Product Change Notification

PCN-ICC-864-2017

Business Unit	Product Line Code	Type of Change	Action	Date of Issue
ICC - Industrial	BE2	Product Change	Notify Distributors and	8/30/2017
Cabinet		Notification	Field

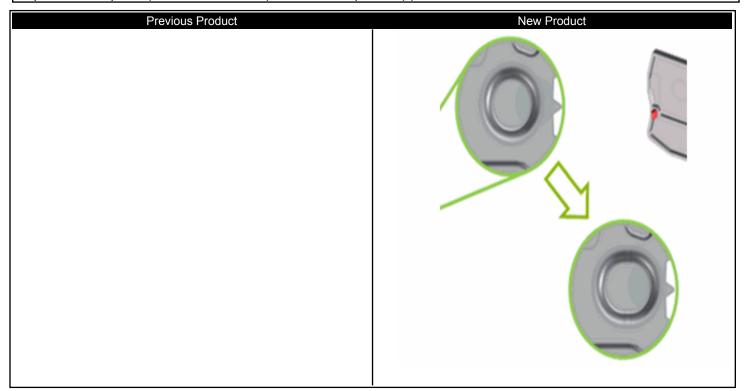
- -The origin is in change of the PT 2.5 Quattro-MT to and L-shaped current bar
- -Change in ST article from round to bean snap-in hole. No need for a new cover, only have to modify existing cover
- -Old cover fits to ST before and after change, the new cover will fit to ST only with bean hole
- -New cover will fit to old and new PT

The reason is the change of the PT 2.5 Quattro-MT from the old PT 2.5 chamber to new R1 Version with L-shaped current bar.
